Technical Service Bulletin: TSB200201	Released Date: 05-Oct-2020
New Variable Geometry Turbocharger Actuator Vented Coolant Drain Line Kits

New Variable Geometry Turbocharger Actuator Vented Coolant Drain Line Kits

Figure 1, Existing Turbocharger Plumbing and Engine Vent Lines.

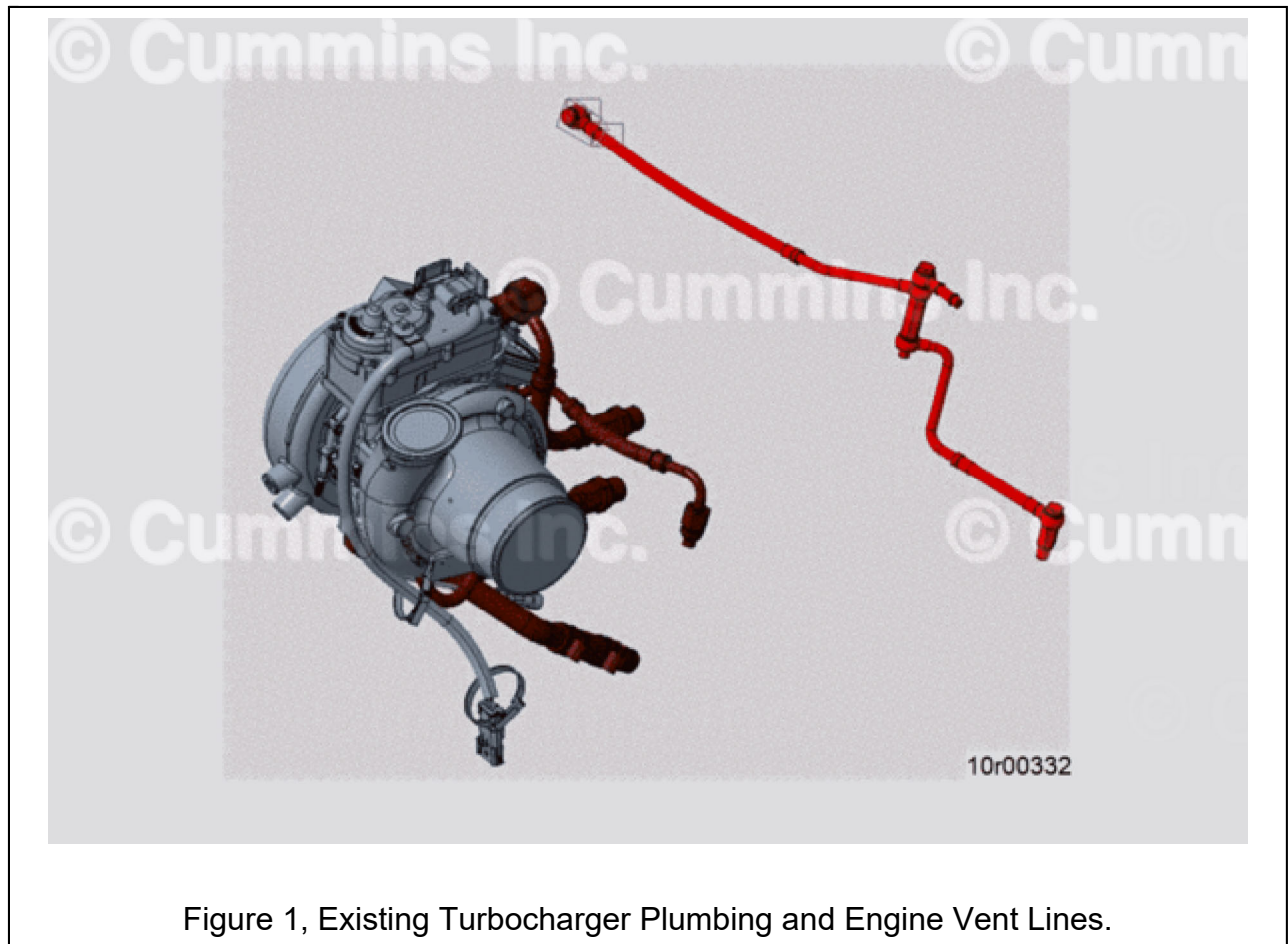
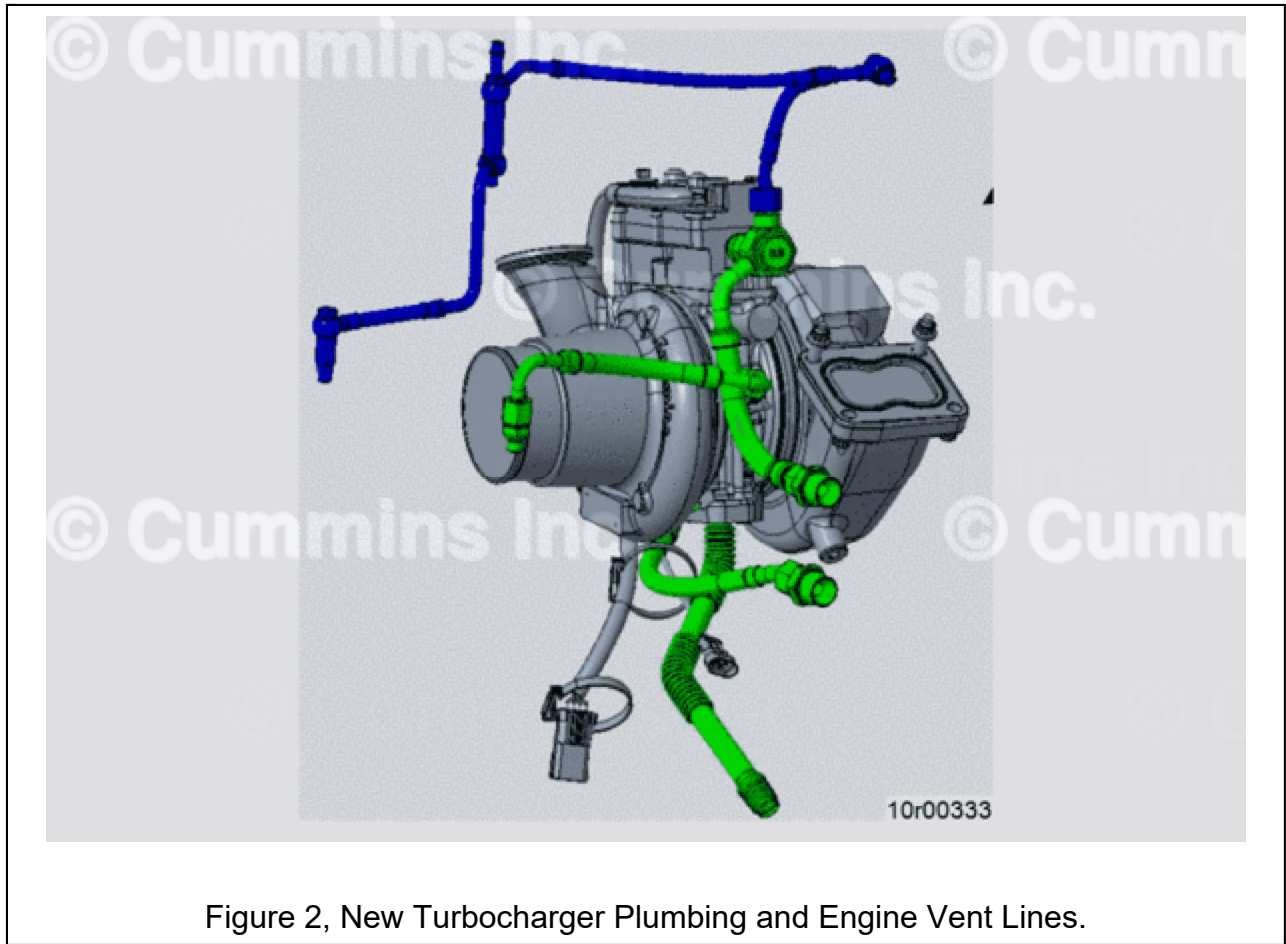
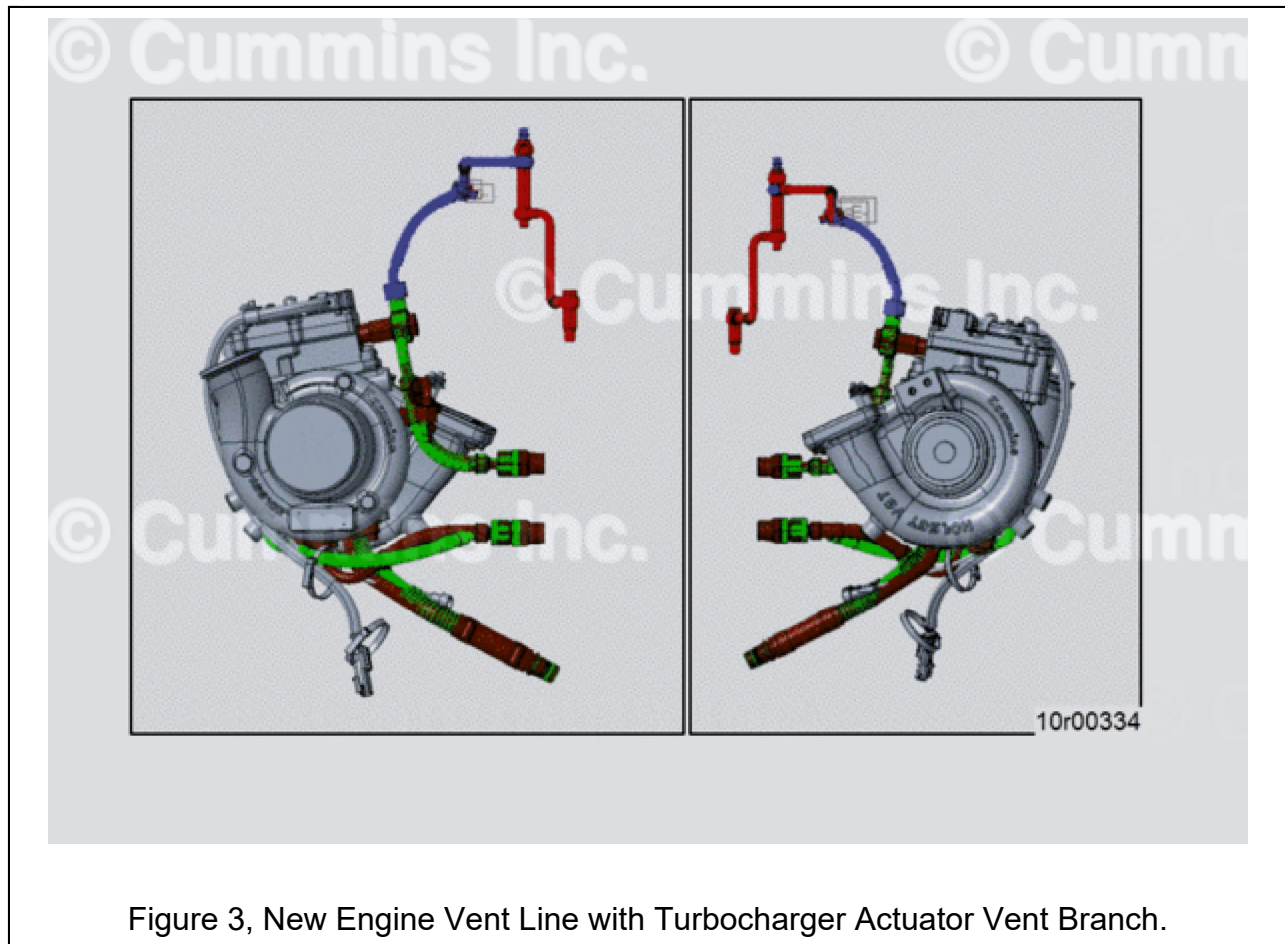
New engine coolant vent and turbocharger coolant drain lines released that features a coolant vent path between the turbocharger actuator and engine coolant vent line.

Insufficient coolant circulation or air venting after engine shutdown due to limited engine compartment air flow.

- See Table 3 in the Service Parts Availability for kit part numbers.
- See Figures 1, 2, and 3 for existing product and service kit layouts.
- For new turbocharger actuator coolant drain line kit installation, see corresponding Service Manual. Reference Procedure 008-017 in Section 08.
- See Table 2 for Installation torque of engine coolant vent line to turbocharge coolant out line, highlighted in Figure 2.

Table 2, Connection Installation Torque Values	
Connection Location	Installation Torque N*m [ft-lb]
1 (Figure 2)	35 [2 6]
